ABINGTON TOWNSHIP

**BOARD OF COMMISSIONERS
REGULAR PUBLIC MEETING**

We have received a copy of the Preliminary Major Subdivision and Land Development Plans consisting of fourteen (14) sheets dated November 22, 2021, and received on November 30, 2021; as prepared by Eastern/Chadrow Associates, Inc. located at 333 E. Street Road in Warminster, PA for the above referenced project. As requested, we have prepared an overview of the above subject preliminary major subdivision and land development project as follows:

AERIAL PLAN
365 CEDAR ROAD
ABINGTON TOWNSHIP, MONTGOMERY COUNTY, PENNSYLVANIA
MADE FOR
PAUL YANNESSA
SCALE: 1"=40' 0 40 80 120 22 NOVEMBER 2021
EASTERN/CHADROW ASSOCIATES, INC.
333 E STREET ROAD • WARMINSTER, PA 18974 • (215) 672-8671 FAX (215) 672-6765
EST. 1967

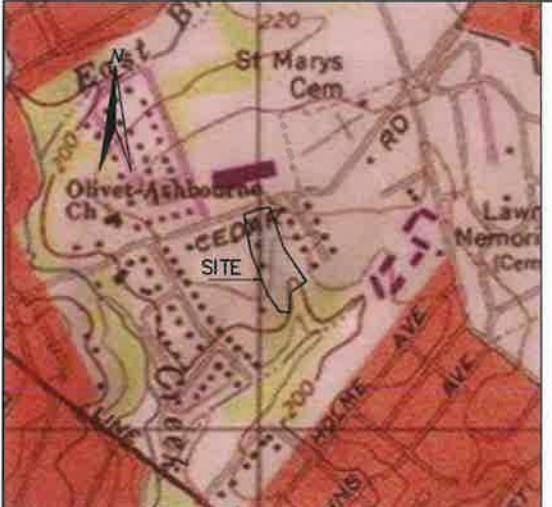
The Applicant has requested a waiver to not be required to show all existing and proposed features, tax parcels, and owners names within 400 feet of the site. The Applicant has provided an Aerial Plan of the parcel on Sheet 3 of the plans set.

We support a partial waiver due to the size and scope of the project, contingent the Applicant shows the tax parcel numbers, owner's names and approx. acreage of the immediately abutting properties of the tract. We also request that the Applicant revise the aerial plan to increase the resolution, zoom out the aerial image, and provide and label a 400' radius surrounding the site.

- 2. §146-11.B.(3) – Existing Features Plan** – The location of property lines and names of landowners within 400 feet of any part of the site to be subdivided or developed. **The Applicant has requested a waiver to not be required to show all existing and proposed features, tax parcels, and owners names within 400 feet of the site. The Applicant has provided an Aerial Plan of the parcel on Sheet 3 of the plans set.**

We support a partial waiver due to the size and scope of the project, contingent the Applicant shows the property lines and names of the immediately abutting properties of the tract. We also request that the Applicant revise the aerial plan to increase the resolution, zoom out the aerial image, and provide and label a 400' radius surrounding the site.

NPDES Permit plan notes:

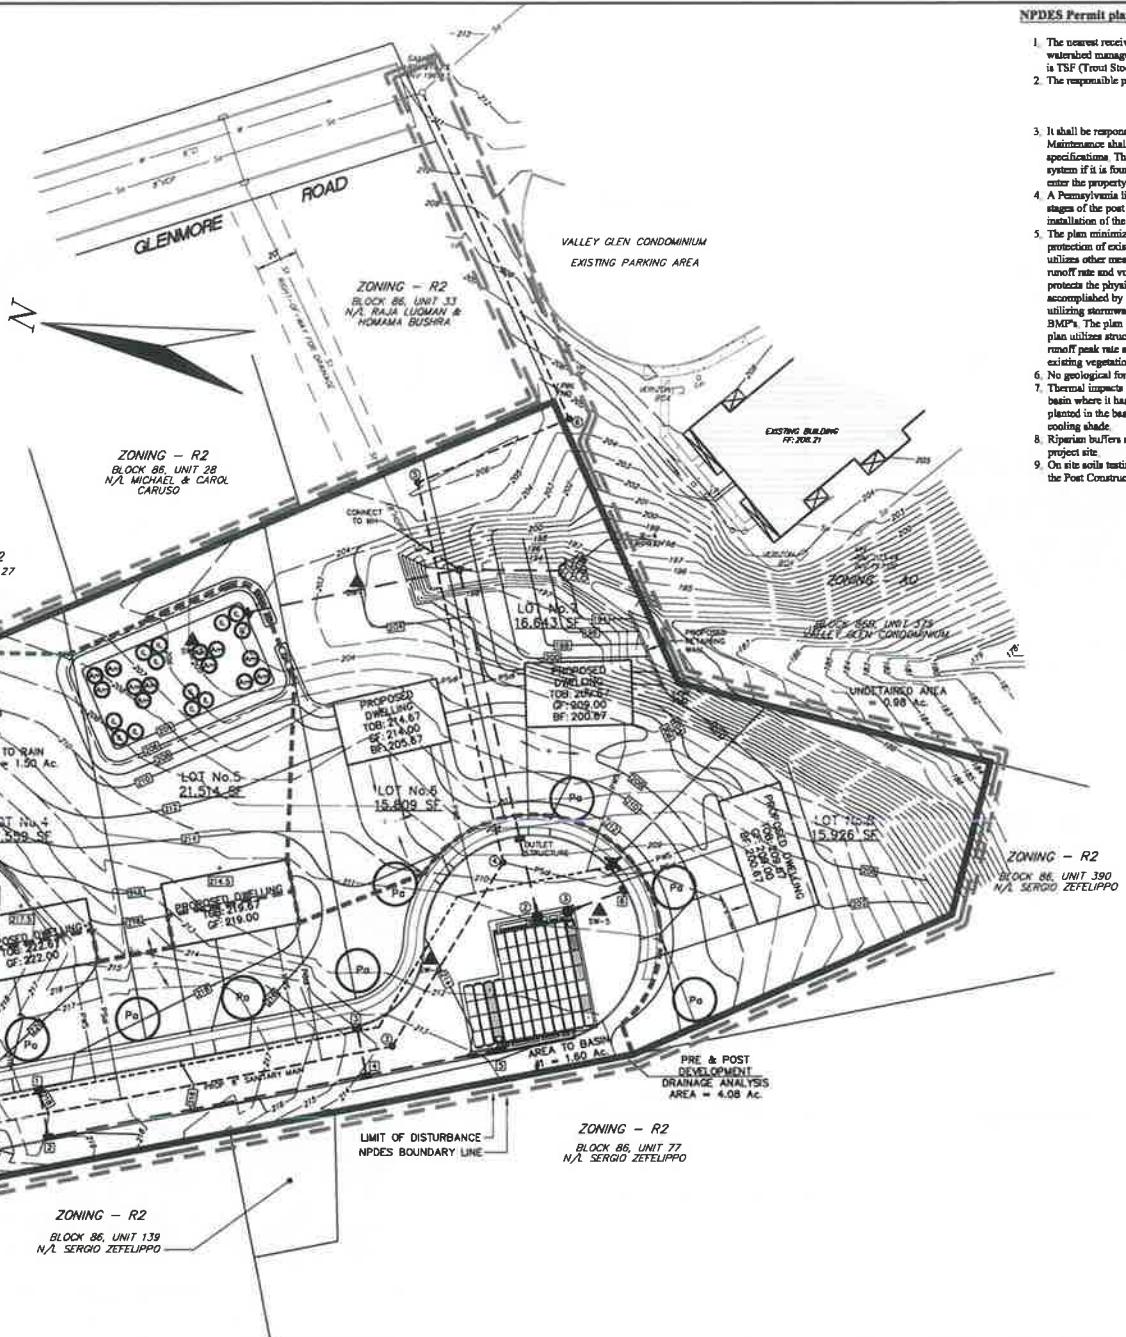
34. The NPDES plan notes on Sheets 4 and 6 shall be corrected to note the nearest receiving surface water is Jenkintown Creek which is part of the Tacony Creek watershed and its designation, instead of the referenced Pennypack Creek.

6. The NPDES notes on Sheet 6 (PCSM) indicate the wrong watershed area, so most likely a cut and paste standard rather than site specific. Should be corrected to reflect that site is in the TTF Watershed. In addition, the notes do not reflect proper maintenance guidelines for rain garden feature. As noted above, proper maintenance of this feature is essential and will be responsibility of homeowner.
